Access Compliance Report

Public Rights-of-Way

(Curb Ramps)

Intersection ID: 19259	Main Street: PEBBLESTONE_DR	Cross Street: VILLAGE_LAKE_DR	Location: NE
ADA ID: 67298D6ED443	Ramp Type: PerpDiag	Initial Pass/Fail: Fail	Overall Compliance: No
			Severity Score: 13.75

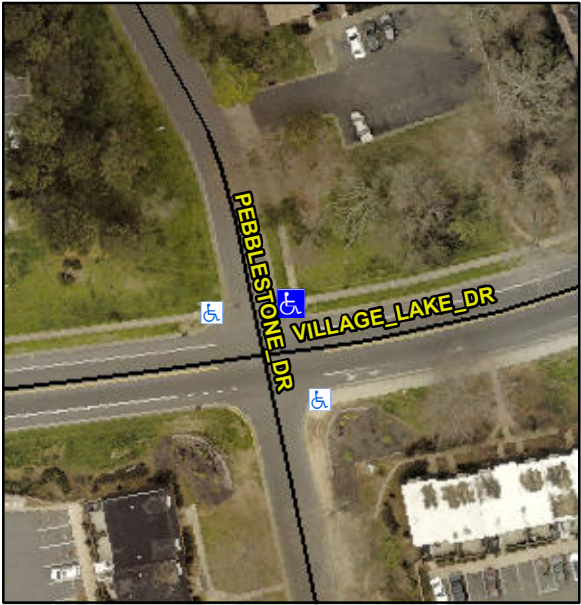
Codes/Mitigation Info/Possible Solution		Field Measurements/Component Compliance			
	Possible Solutions:				
	Remove & Replace Curb Ramp With Two New Directional Ramps or Equivalent.				
	Surveyor Notes:				
	N/A				
	PROW/ADA:				
	Not Found, R304.2.2, R304.5.3				
Street 1 Name	PEBBLESTONE DR				
Stop Condition-Street 2	StopSign				
Street 2 Name	VILLAGE LAKE DR				
Stop Condition-Street 1	None				
Total Cost:		\$	3200.00
